FORREST HOUSE

BLOCK 11 SECTION 7 FORREST

DRAWING NO.	TITLE
WA000	PLAN - LOCATION & DRAWING SCHEDULE
WA004	PLAN - DEMOLITION
WA005	PLAN - SITE
WA007	SOFT LANDSCAPE ANALYSIS
WA008	SHADOW DIAGRAMS
WA009	SHADOW DIAGRAMS
WA010	SHADOW DIAGRAMS
WA011	PLAN - AREA GFA
WA011	PLAN - BASEMENT
WA102	PLAN - GROUND FLOOR
WA103	PLAN - FIRST FLOOR
WA104	PLAN - ROOF
WA200	STREETSCAPE ELEVATION
WA201	ELEVATIONS
WA202	ELEVATIONS
WA300	SECTIONS
WA900	STREET PERSPECTIVES

DRAWING TITLE  
**SHADOW DIAGRAMS**  
SCALE  
**As indicated @ A1**

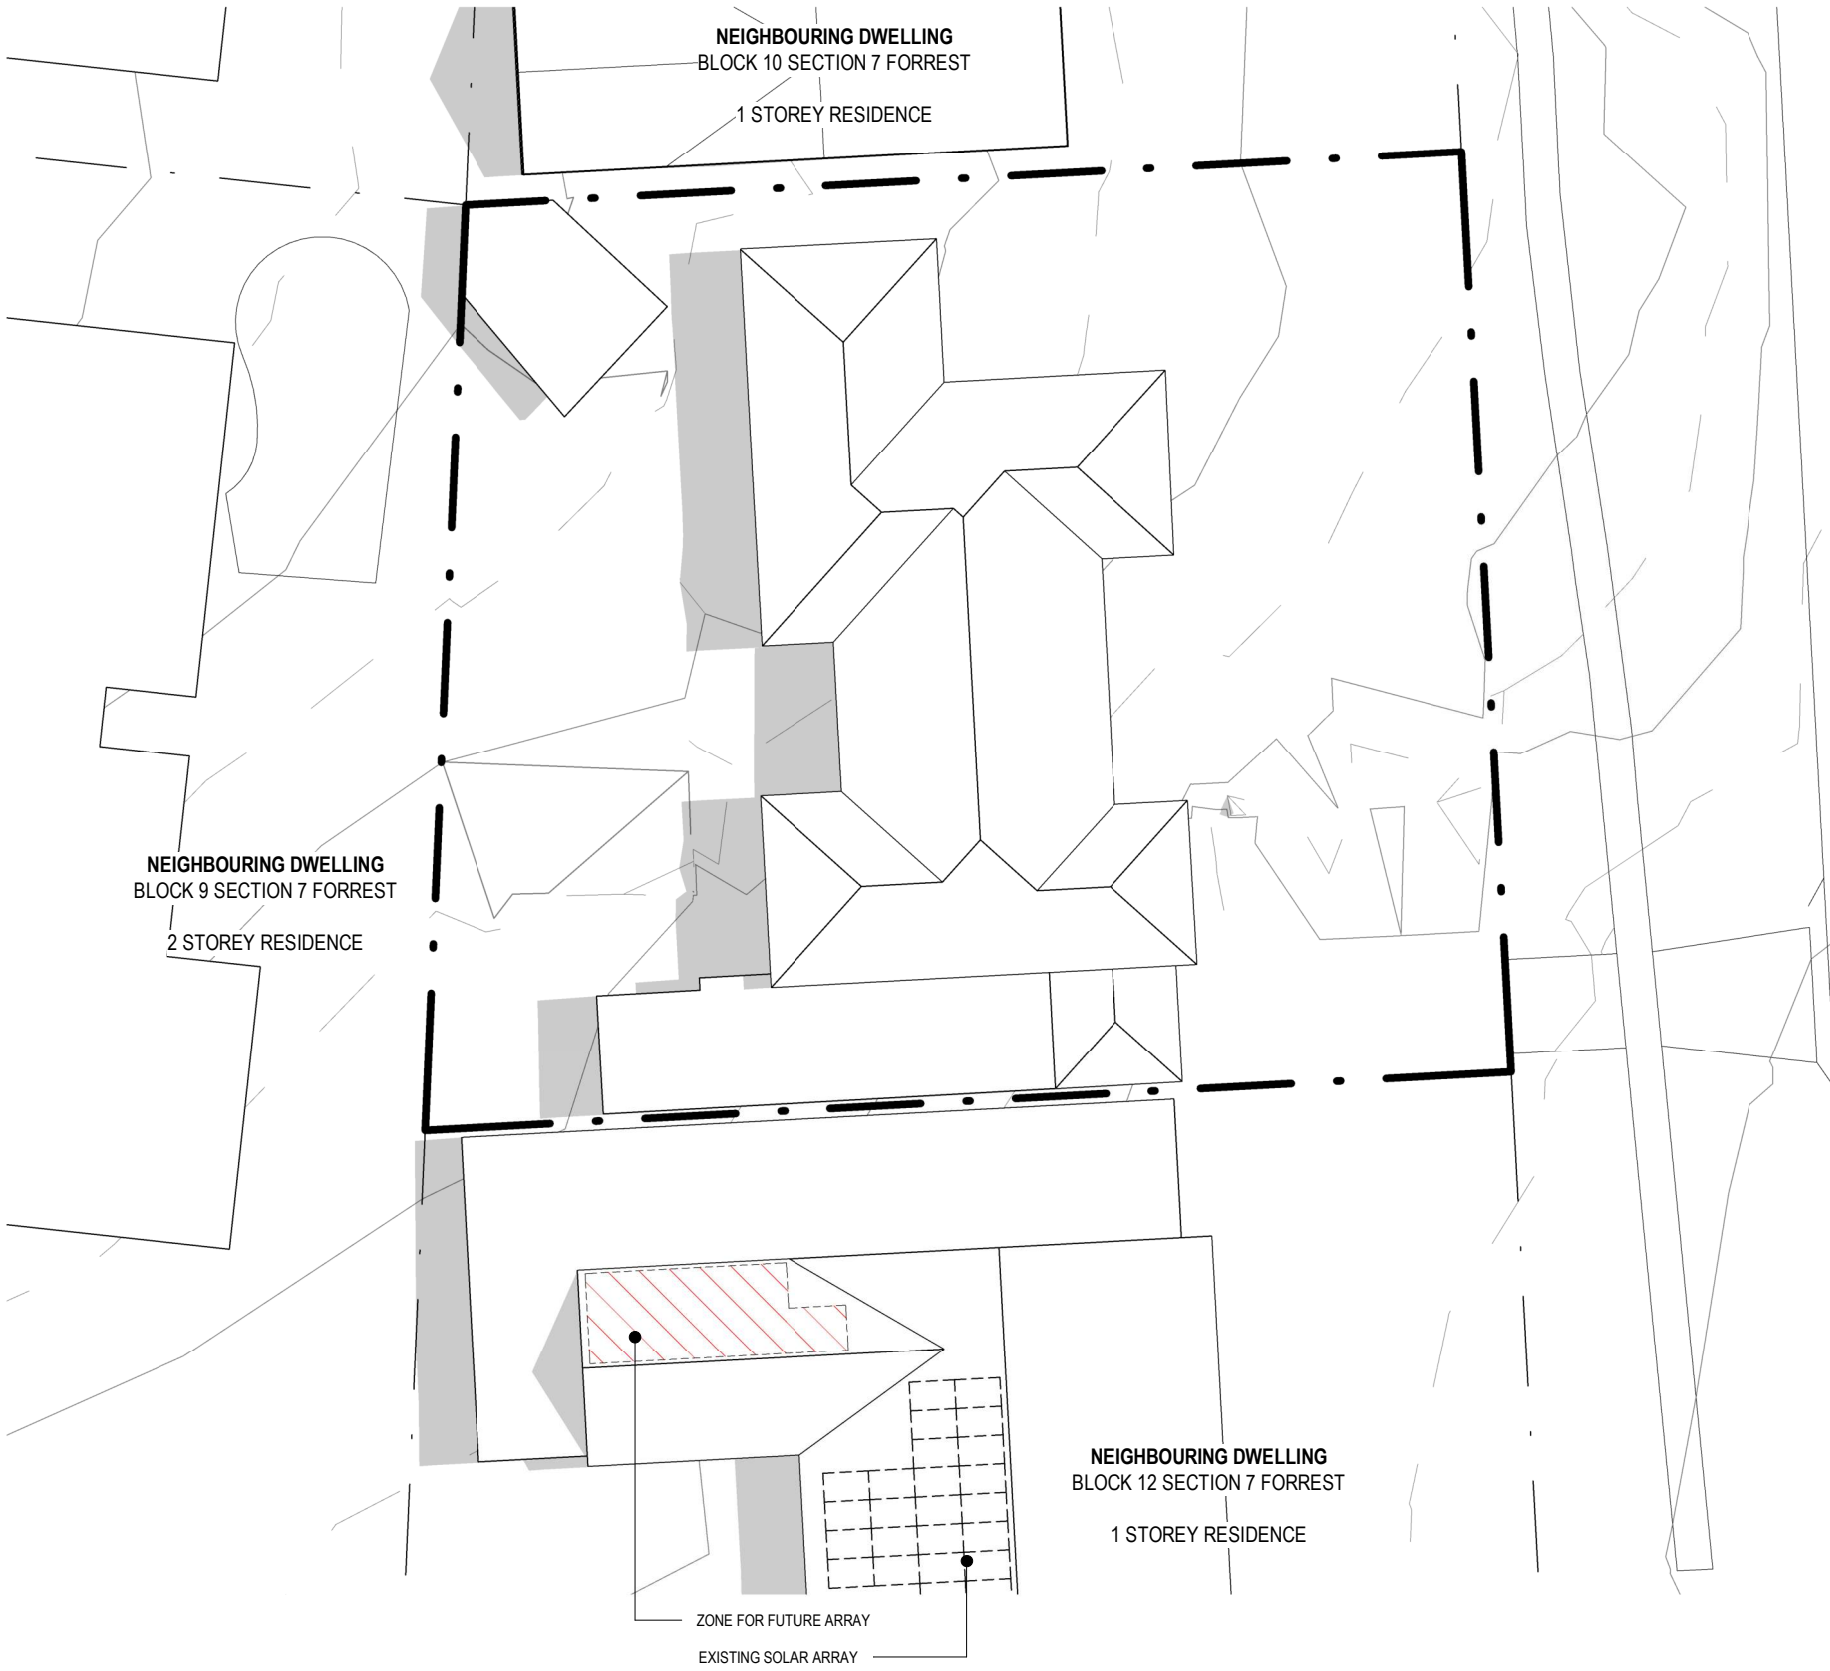
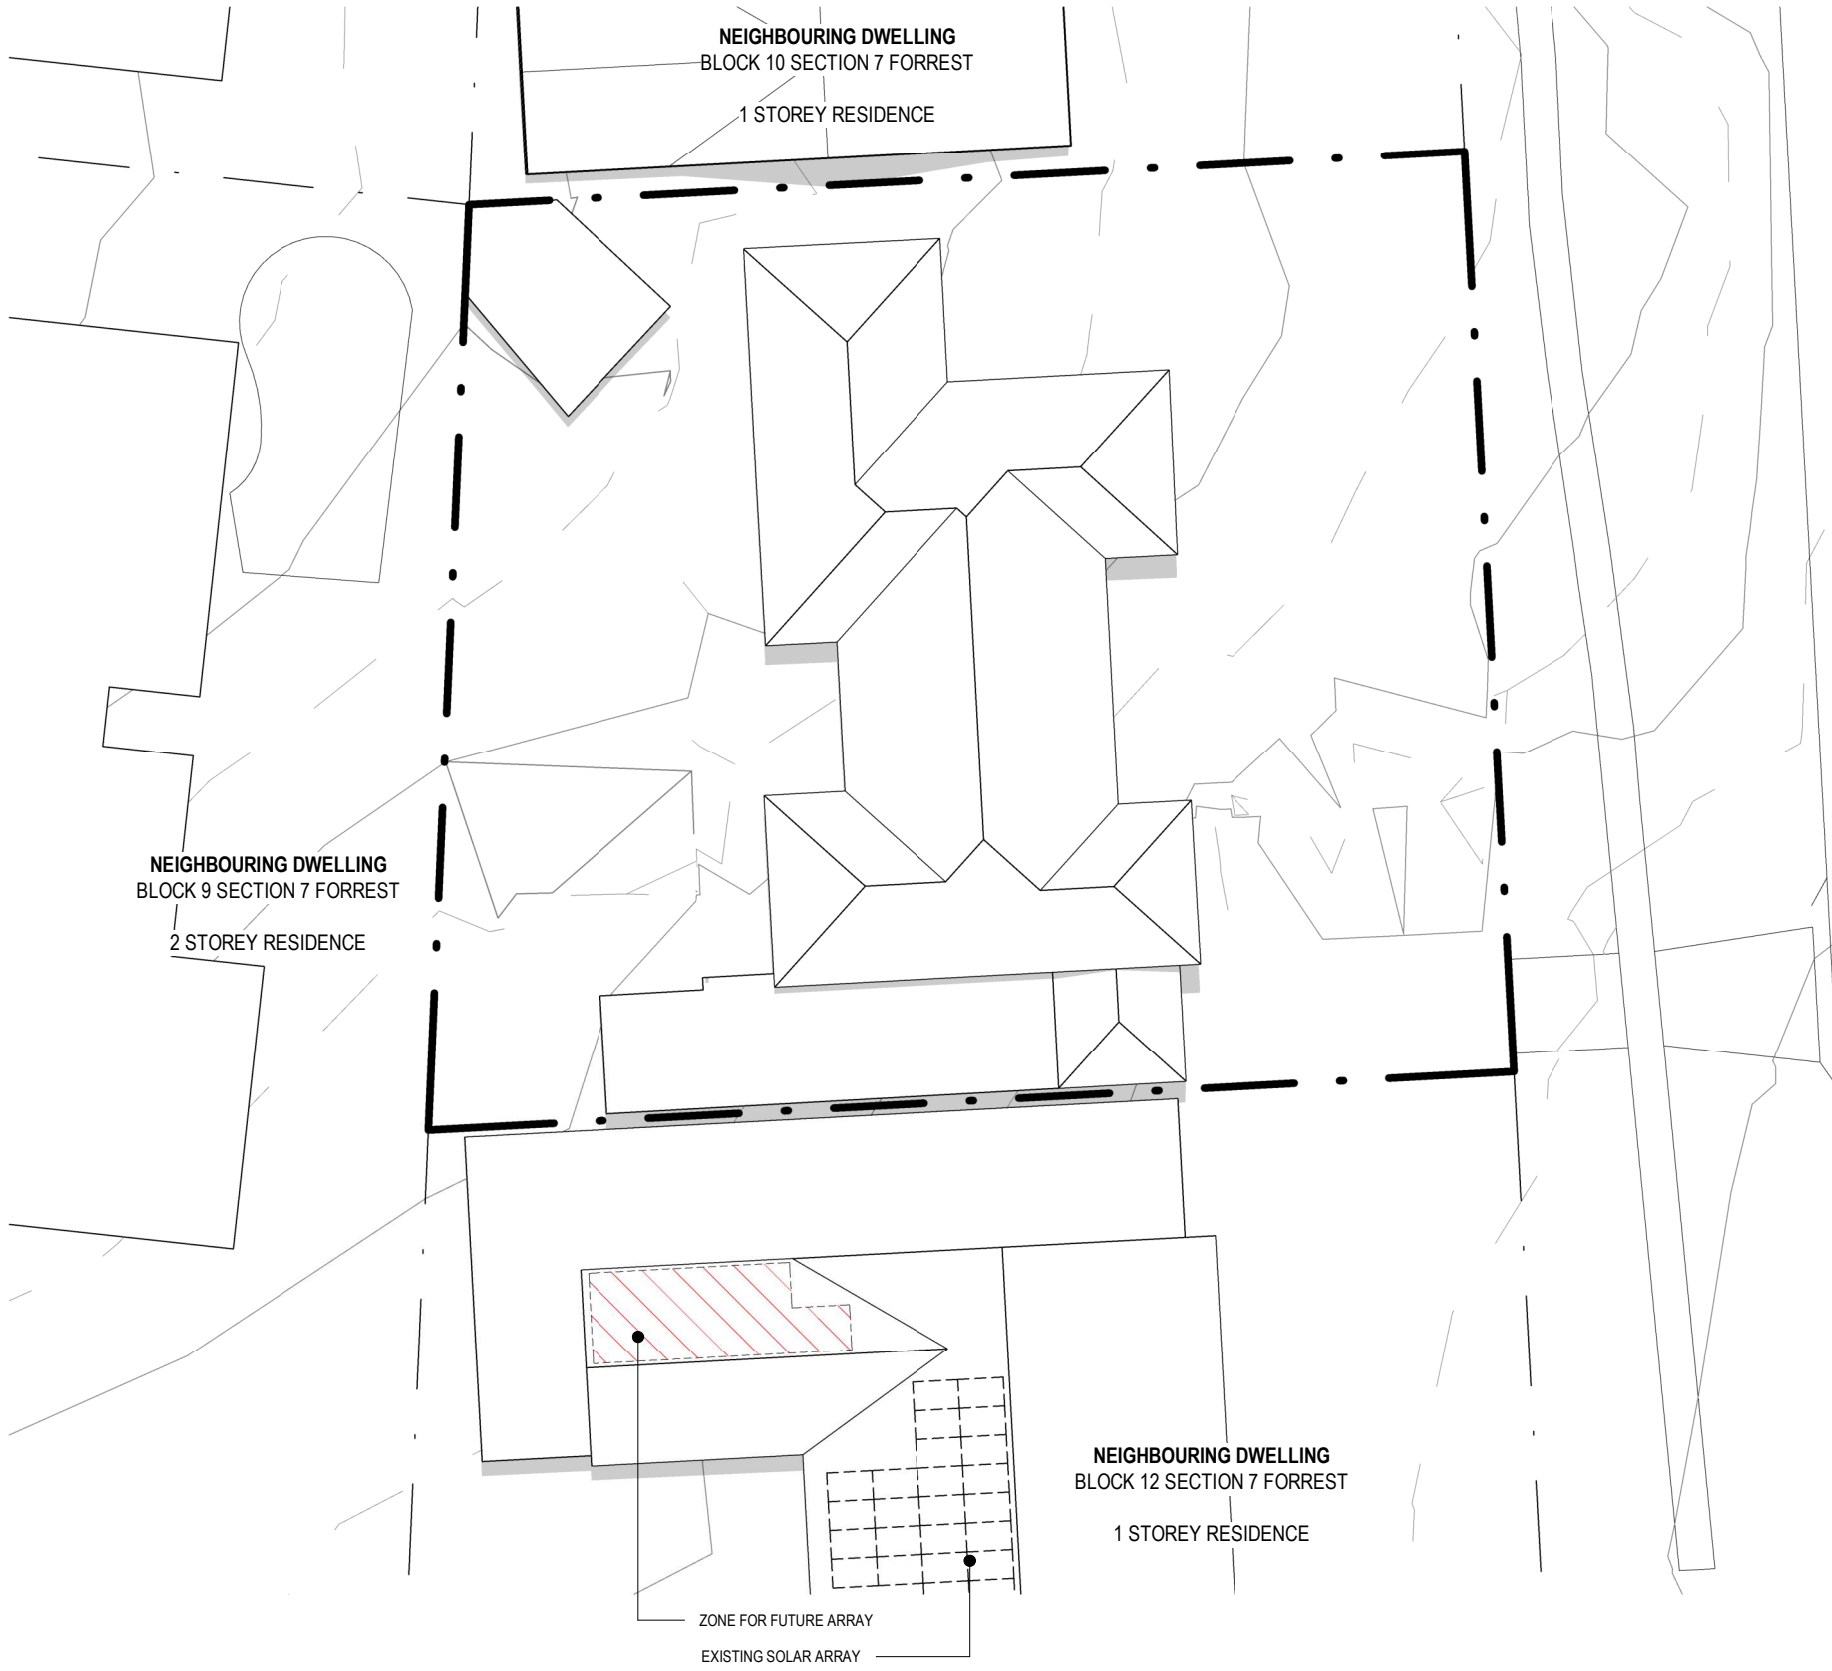
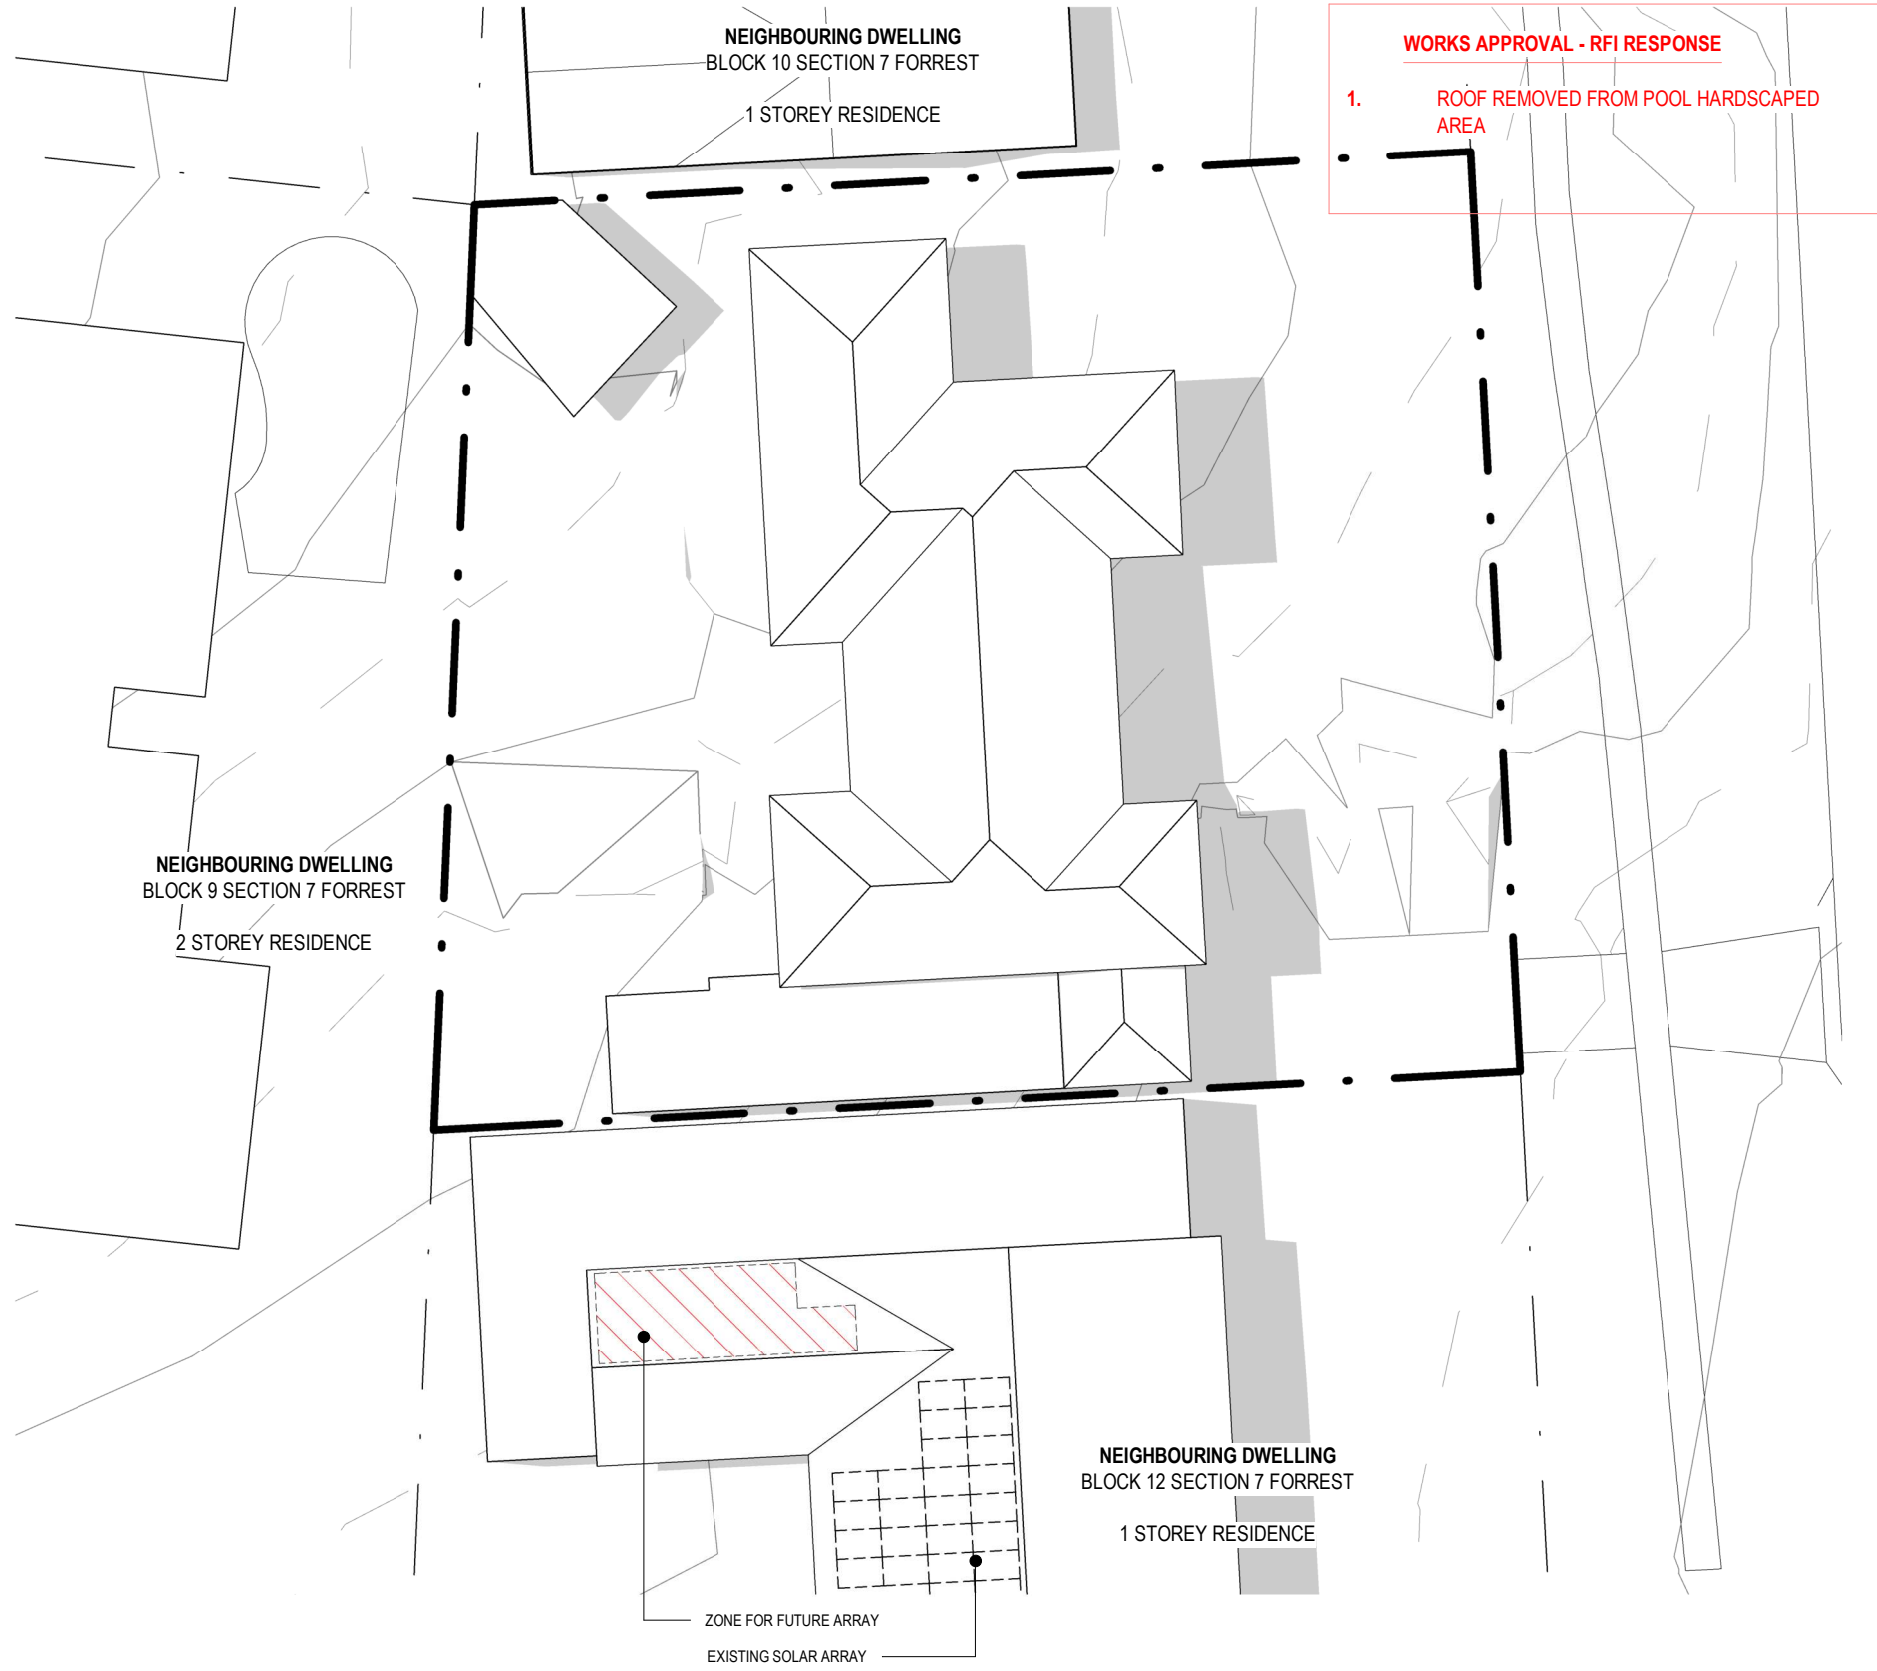
- EASTERN WALLS MOVED 240mm WEST TO SETBACK LINE.
- WESTERN WALLS MOVED 500mm EAST.
- FACADE ARTICULATION WALL REMOVED.
- POOL PAVILION WALLS REMOVED. AREA NOW AN UNENCLOSED COVERED AREA.
- SOFT LANDSCAPING AREA INCREASED, GFA DECREASED.
- SHADOW EXTENT REDUCED AS A RESULT OF THE BUILDING FOOTPRINT DECREASING
- STUDY AND DINING ROOMS INCREASED IN DEPTH. MASTER BED PLANTER REMOVED.
- SOUTHERN LANDSCAPE ALTERED FOR GREATER VISUAL PRIVACY.
  - FEATURE TREE CENTRED TO MASK VIEWS TO/FROM STAIR
  - ADDITIONAL PLANTING ADDED TO BOUNDARY WALL
  - ADDITIONAL LARGER PLANTING ADDED TO KITCHEN PLANTER (REFER LANDSCAPE DOCUMENTS)
